Agenda Item # 2

SUB-003202-2025

Resubdivision of and Addition to Lot 7, Heron Landing
Unit One

RESUBDIVISION OF AND ADDITION TO LOT 7, HERON LANDING, UNIT ONE

DETAIL SITE PLAN

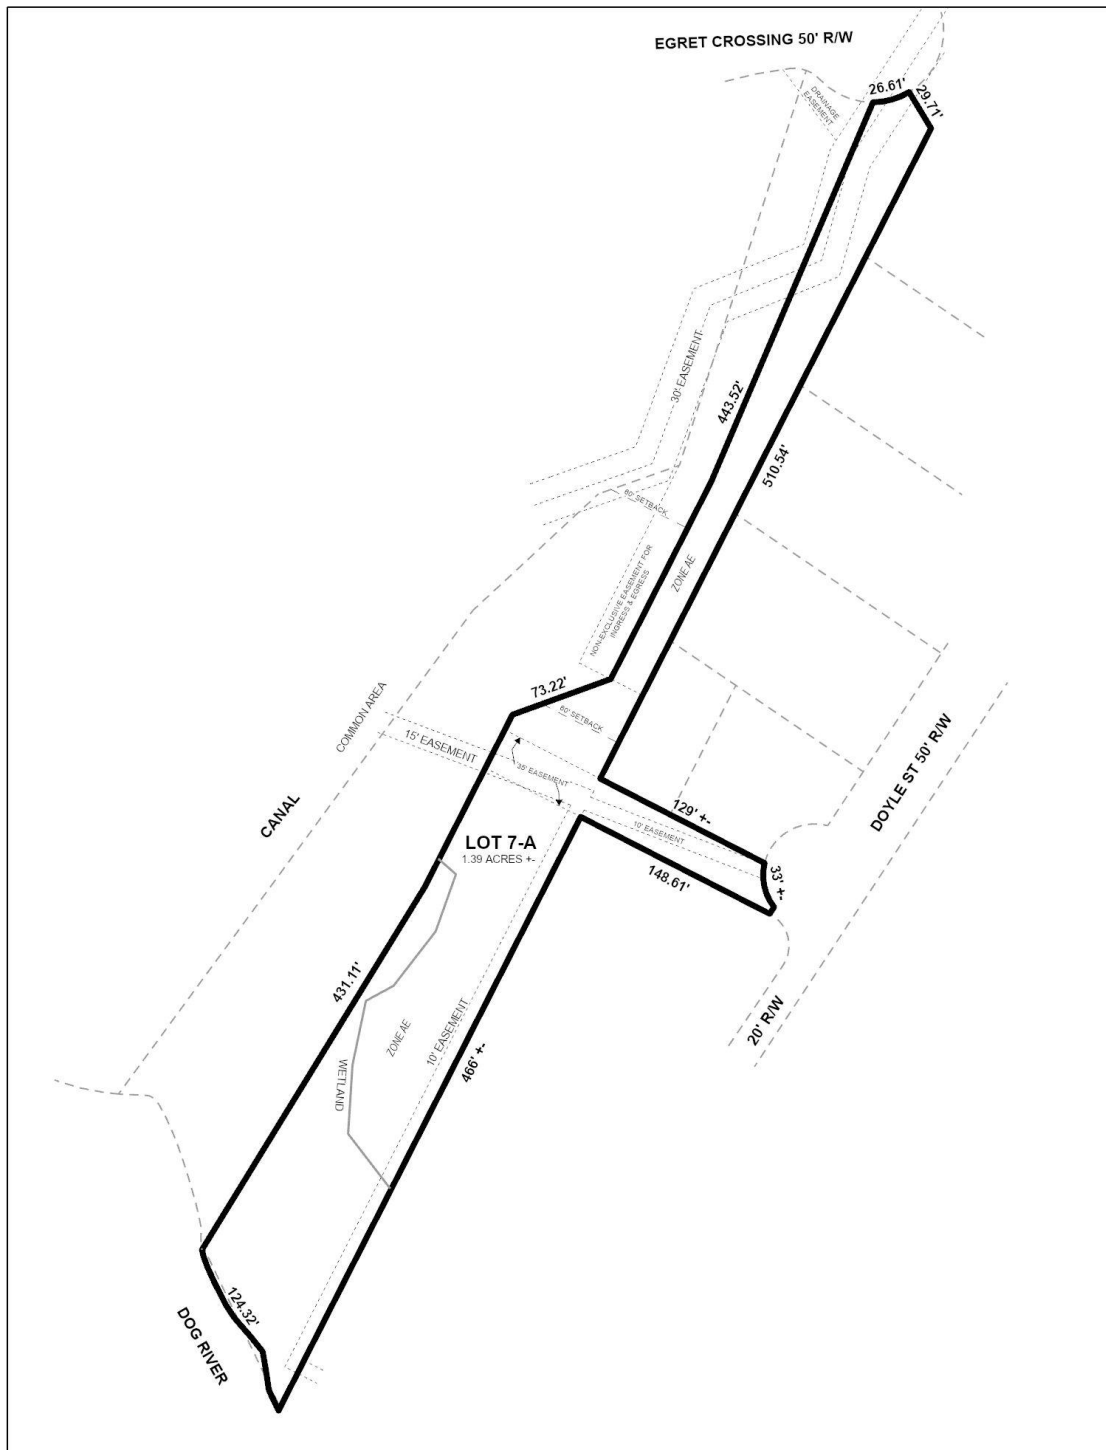
The site has frontage on cul-de-sacs associated with Egret Crossing and Doyle Street. The Egret Crossing cul-de-sac has a current radius of 50 feet, and requires a 60-foot radius. Therefore, if approved, dedication would be required to provide a 60-foot radius within the Egret Crossing cul-de-sac. The Doyle Street cul-de-sac has a current 36-foot radius and also requires a 60-foot diameter. Therefore, if approved, dedication would be required to provide a 60-foot radius within the Doyle Street cul-de-sac. The curve data table should be revised to provide all data after any required dedication.

Double frontage lots are discouraged by Section 6.C.7. of the Subdivision Regulations. If approved, a waiver of 6.C.7. will be required, and access should be limited to one (1) street frontage.

The preliminary plat illustrates the 25-foot minimum building setback line from Egret Crossing where the lot is at least 25 feet wide, and this should be retained on the Final Plat, if approved. The plat should be revised to illustrate a 25-foot minimum building setback line off the Doyle Street cul-de-sac as blocked-out within the main part of the lot where the “finger” intersects. The lot size label in both square feet and acres should be retained on the Final Plat, if approved, or a table should be furnished on the Final Plat providing the same information.

As proposed, Lot 7-A would exceed the depth-to width ratio of Section 6.C.3. of the Subdivision Regulations and would require a waiver of that section, if approved.

The preliminary plat illustrates various drainage, sanitary sewer, and ingress and egress easements within the site. These should be retained on the Final Plat, if approved, and a note should be furnished on the Final Plat stating that no structure shall be constructed or placed within any easement without the permission of the easement holder.

1. Dedication to provide a 60-foot radius within the Egret Crossing cul-de-sac;
2. Dedication to provide a 60-foot radius within the Doyle Street cul-de-sac;

3. Revision of the curve data table to provide all data after any required dedication;
4. Placement of a note on the Final Plat stating that access is limited to one street frontage;

5. Retention of the 25-foot minimum building setback line from Egret Crossing where the lot is at least 60 feet wide;
6. Revision of the plat to illustrate the 25-foot minimum building setback line off the Doyle Street cul-de-sac as blocked-out within the main part of the lot where the “finger” intersects;

7. Retention of the lot size label in both square feet and acres, revised for any required dedication, or the furnishing of a table on the Final Plat providing the same information;

8. Placement of a note on the Final Plat stating that no structure may be constructed or placed within any easement without the permission of the easement holder;
